SITE PLAN DEVELOPMENT PLAN

WARREN AVENUE TOWNHOMES

1st Review
Ashley Duncan
Aurora Water Utilities
aduncan@auroragov.org

WARREN STREET TOWNHOMES SITE PLAN

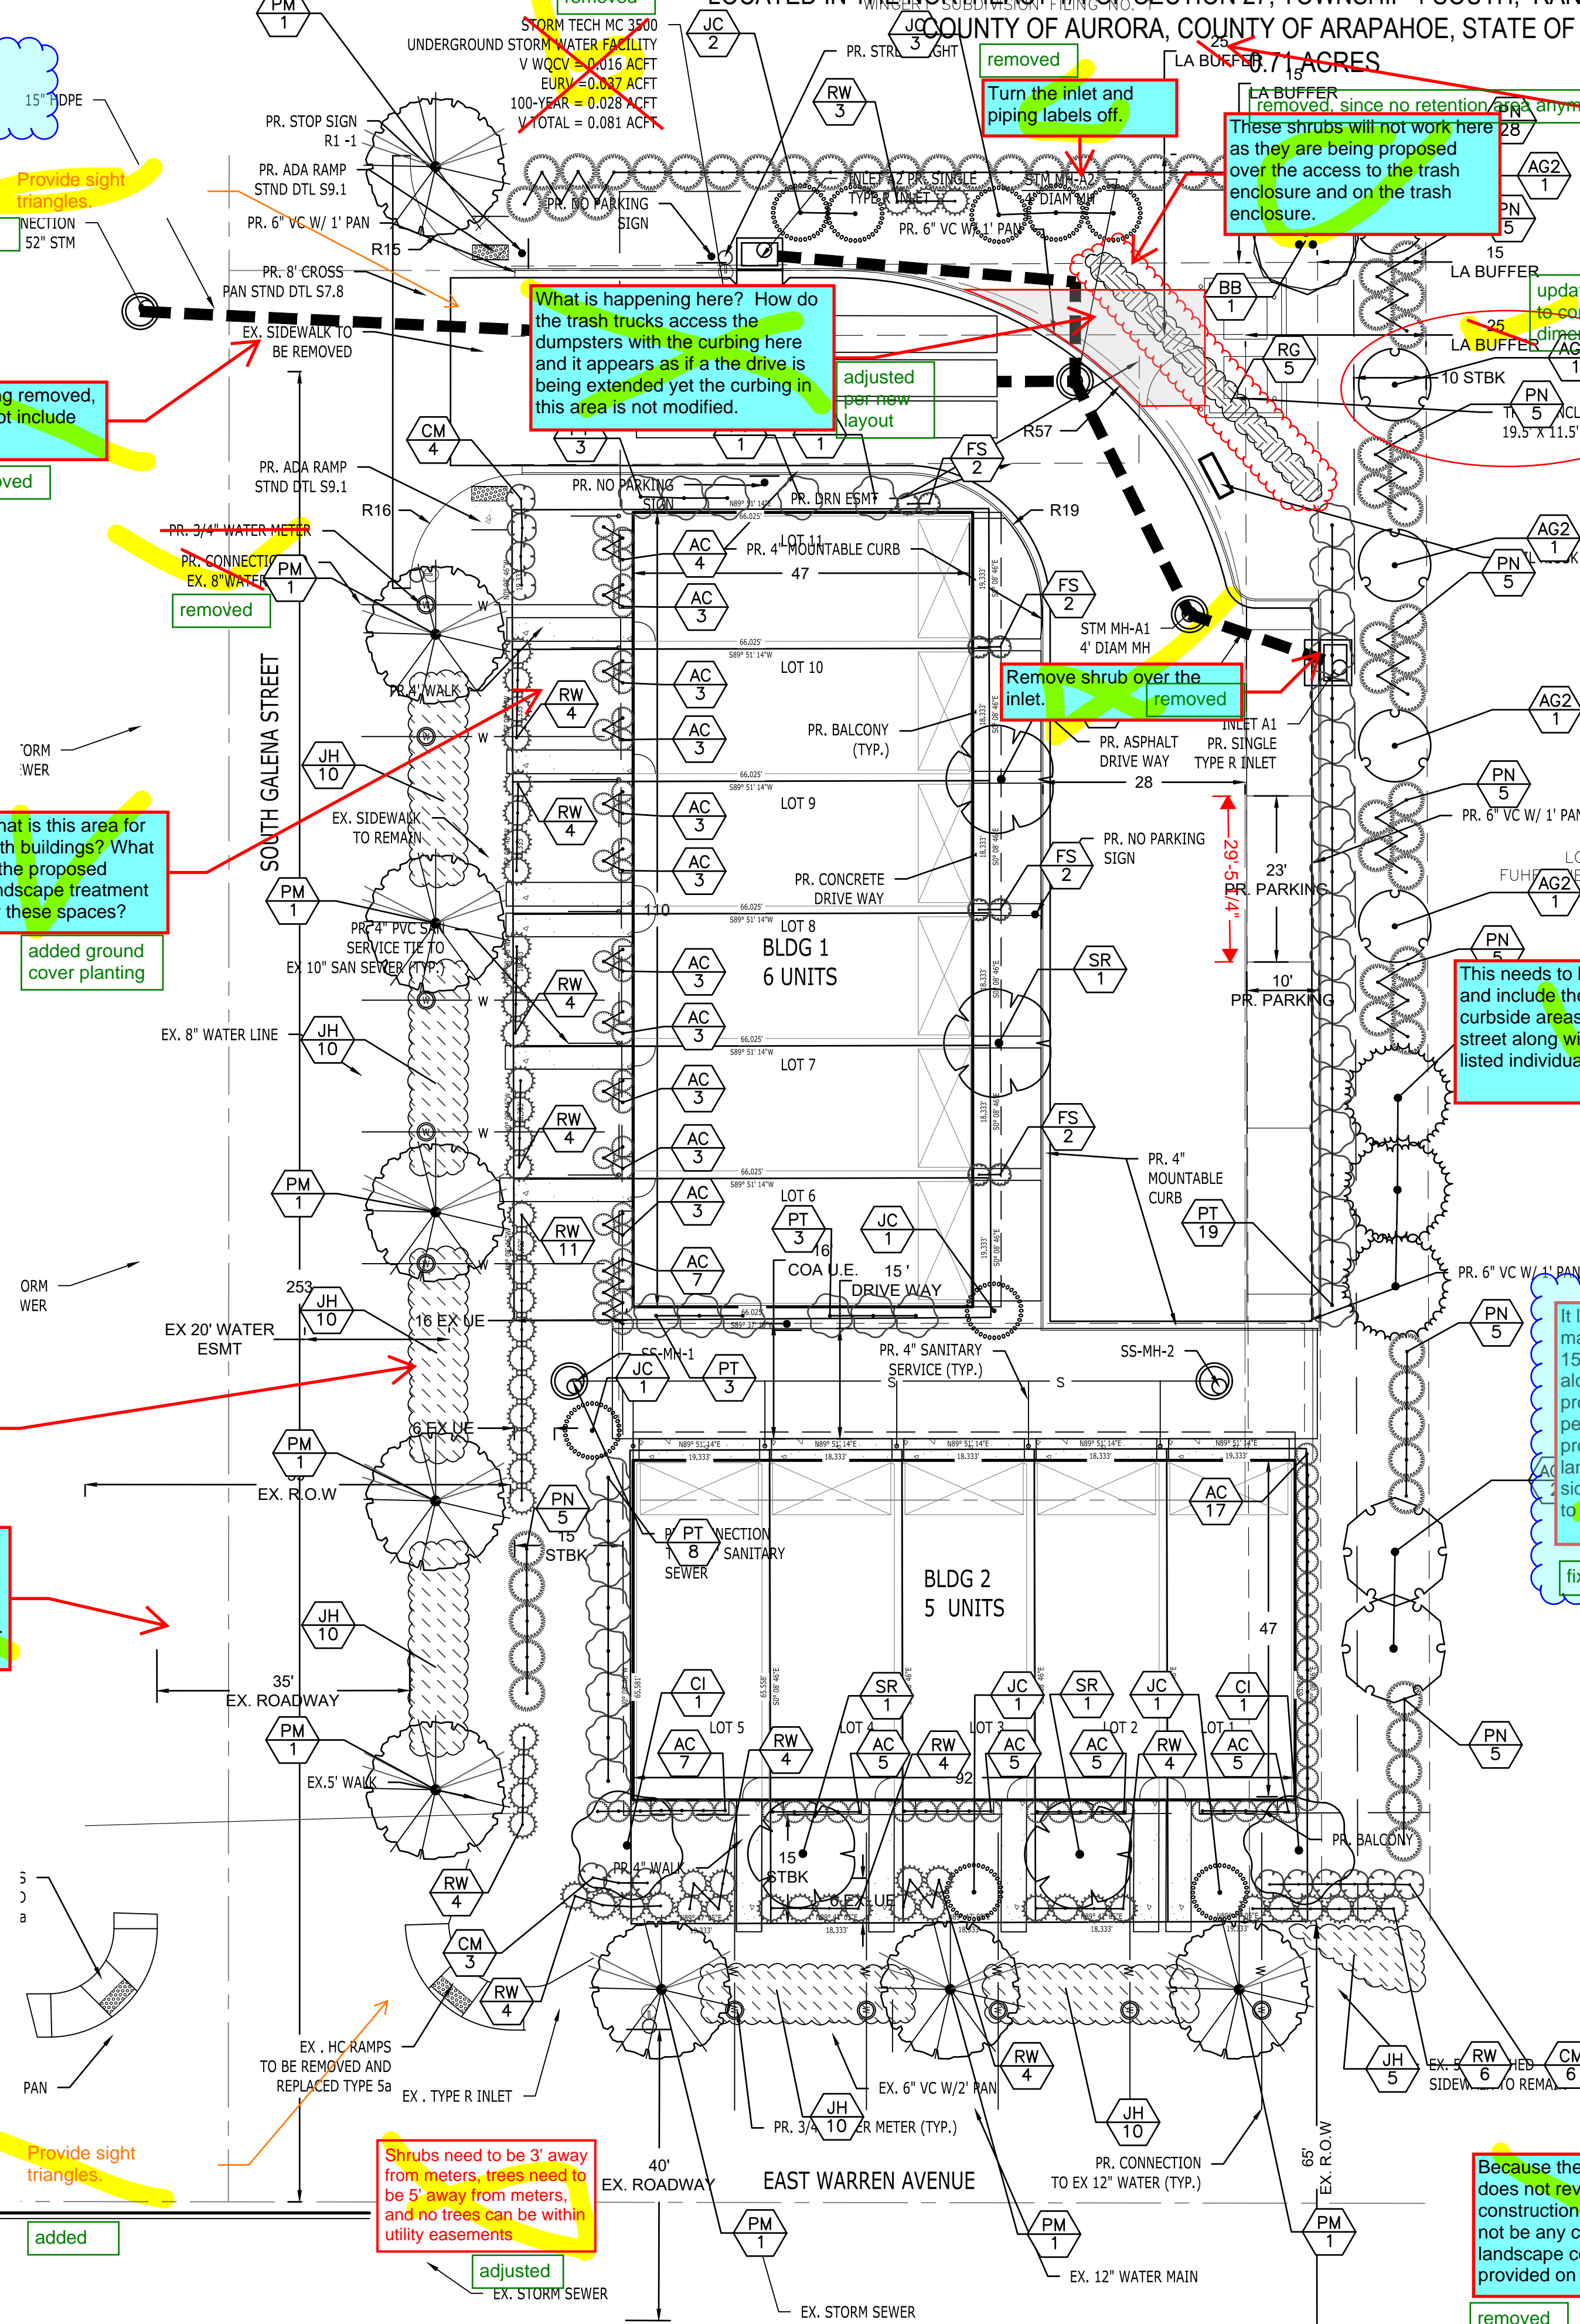
added Add "Not for Construction" to all landscape plan sheets. This drawing is not scaling correctly.

updated Show the property line darker and as a traditional line type. A long dash and two short dashes.

added Include the easements labeled and dimensioned. See sheet 3 for location of fire hydrant. Add to landscape plans.

Will there be any monument signage proposed?

Provide sight triangles

Verify that plants meet the sight distance requirements in the Roadways manual. Figure is below. Trees can be in the sight triangle. Will evaluate the plants when sight triangles are on plans.

This appears to be the curbside area. According to code, this area is supposed to have a variety of plant shrub types that differ in height, color and width. What is being proposed appears to be all junipers.

Include the actual street, curb, sidewalk etc. Refer to the Site and Grading Plan sheets in the plan set.

Please provide a written scale as well. The drawing scale is not 40 and it isn't quite 20 scale either. Please address.

Because the Planning Department does not review landscape construction drawings, there should not be any contractor and/or landscape construction notes provided on the plan.

It looks like an attempt is being made to provide the minimum 15' wide landscape buffer along the north and eastern property lines. This is permitted by code WITH the provision of a wall and landscaping along the exterior side. There does not appear to be a wall being proposed.

Remove shrub over the inlet.

Remove the inlet and piping labels off.

While a nice tree, these require significant amounts of water. Please replace with a more water conserving tree.

on bldg facade, not on ground

added SECTION 52" STM

adjusted and confirmed plants ht compliant with triangle requirement

added ground cover planting

added

fixed, added a low wall

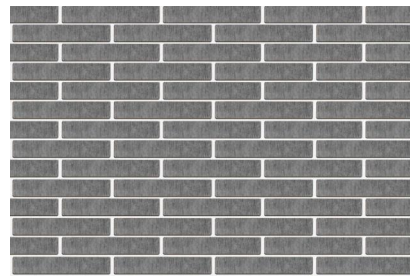
Please provide a beak down
percentage of the material

In the elevation -
Please provide a break
down percentage of the
building material: Per
UDO Code Table 4.8-6
(50 percent shall be
clad in brick or stone;
or 75 percent shall be
clad in stucco; or 75
percent shall be clad in
a combination of
stucco and brick, or
stucco and stone.)

Per code section
146-4.8.5.c: Each
primary structure or
portion of a primary
structure with a height
of 30 feet or more and
more than two stories
shall use vertical
articulation to present a
clear base, middle and
cap to the building on
each façade facing a
street or a Residential
zone district. Please
provide a more
pronounced base,
middle, and cap on all
elevation façades with
the next submittal

1
7 **South Elevation**
From S Galena St

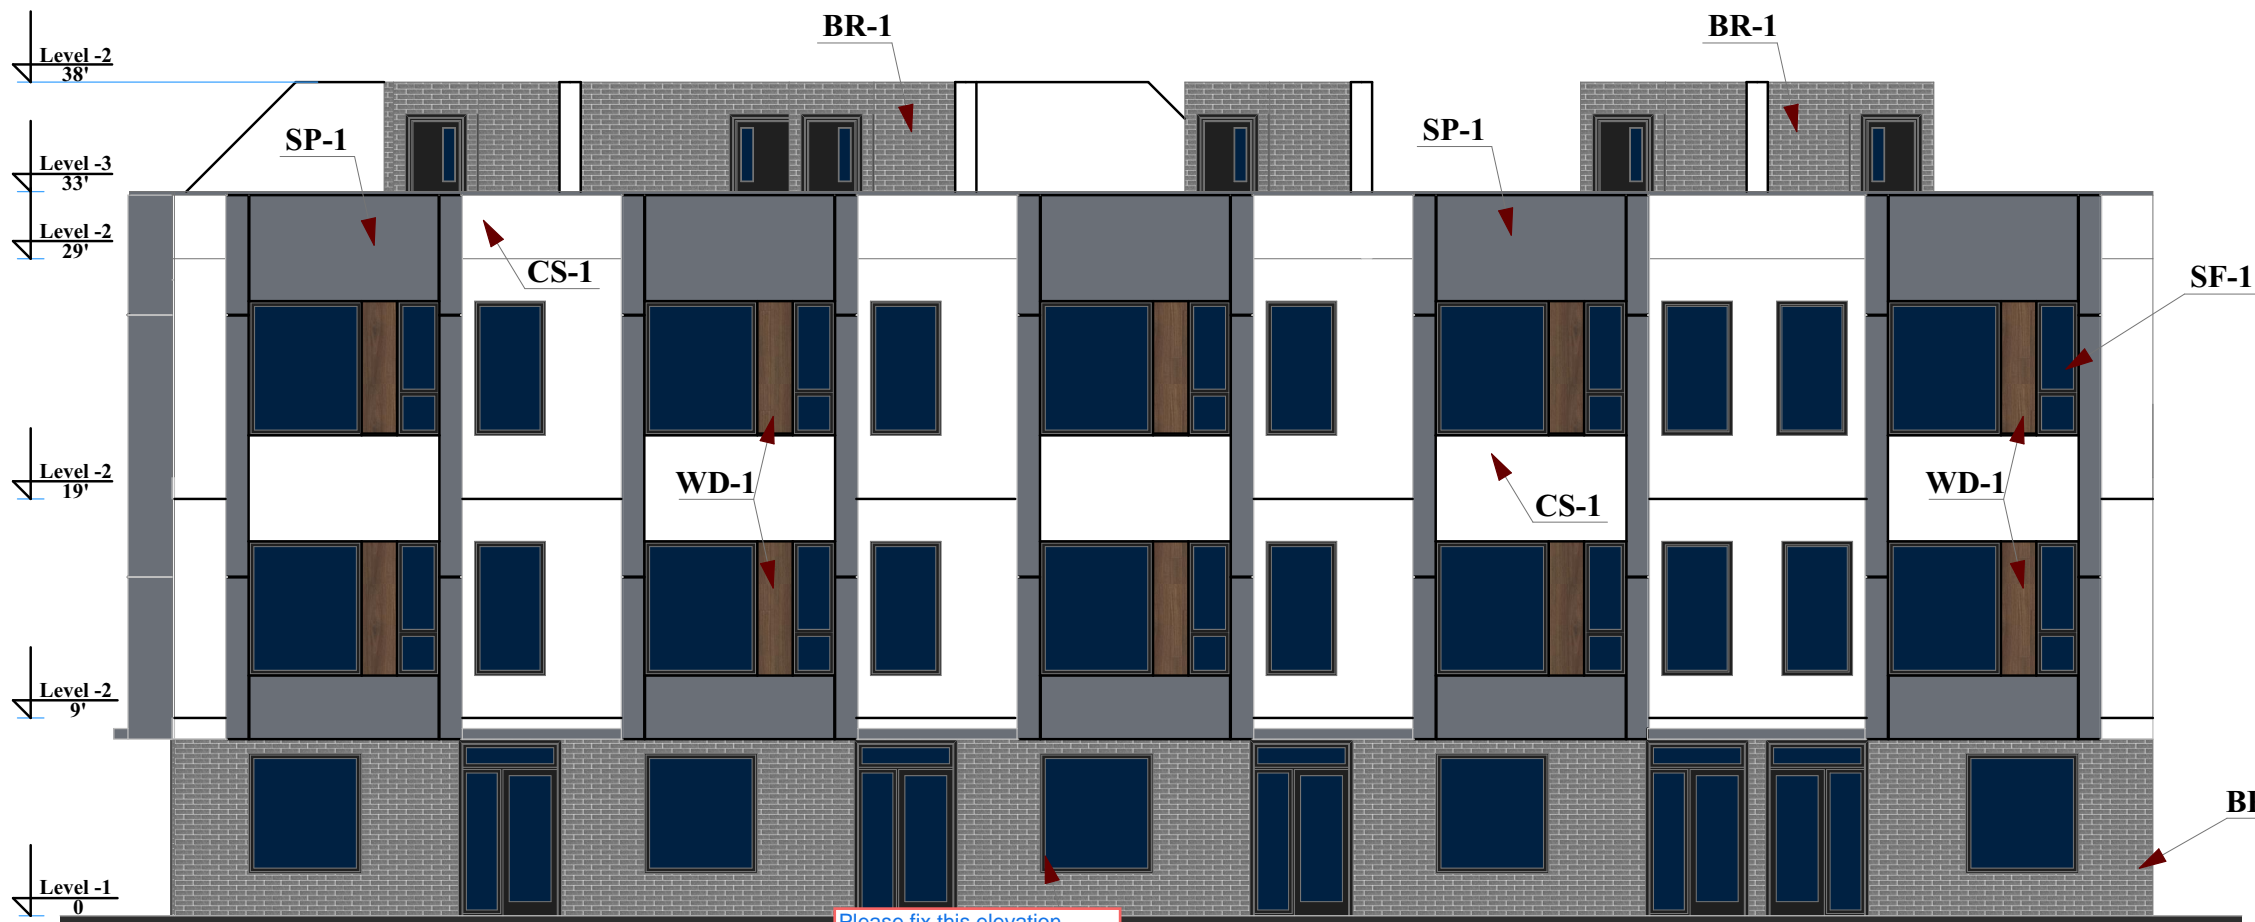
This is West elevation
Please correct it

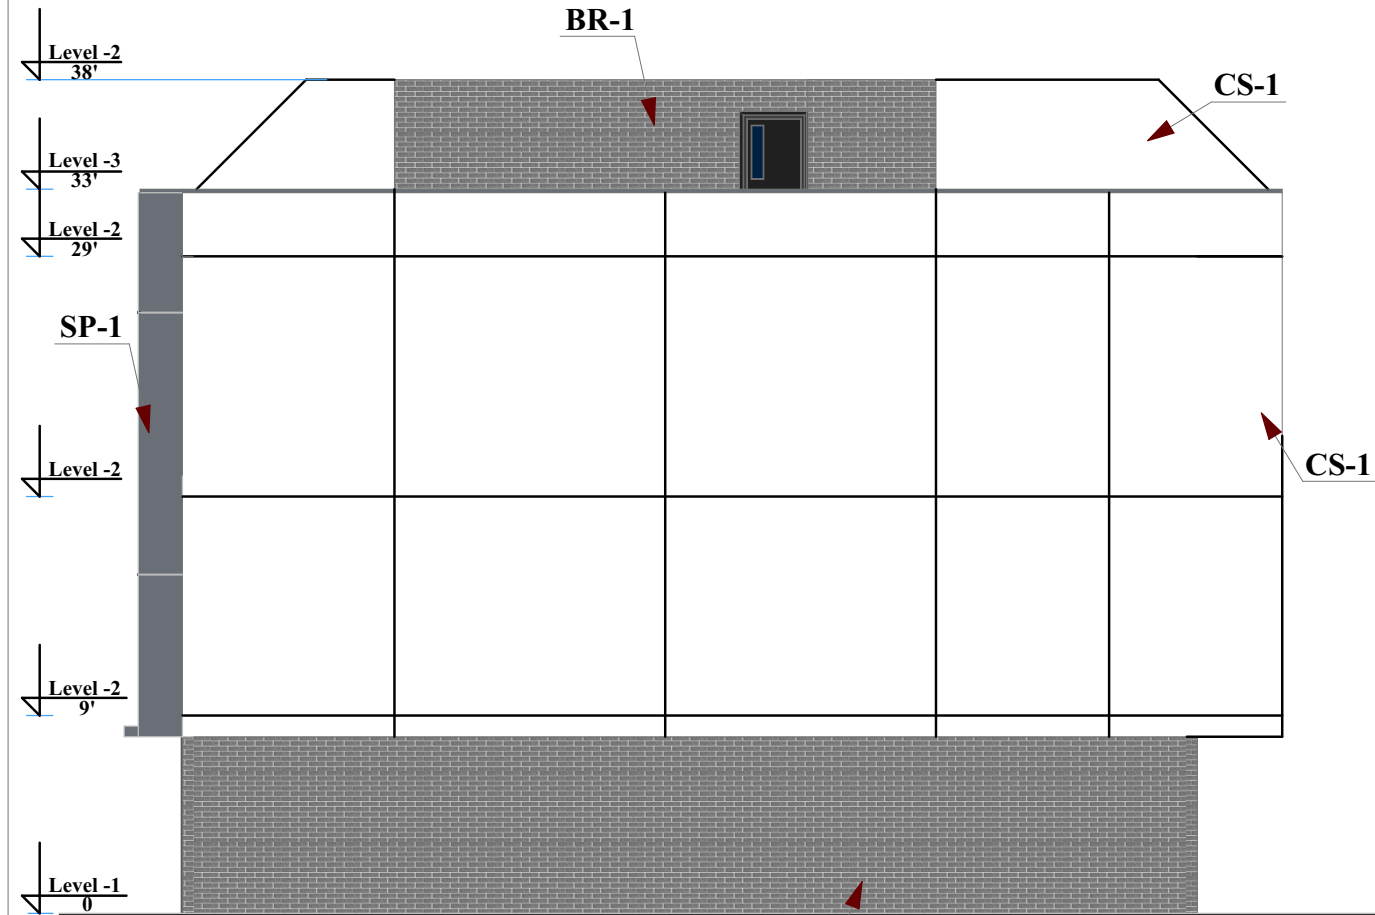
Show monument sign location, setbacks, and elevations with the next submittal.
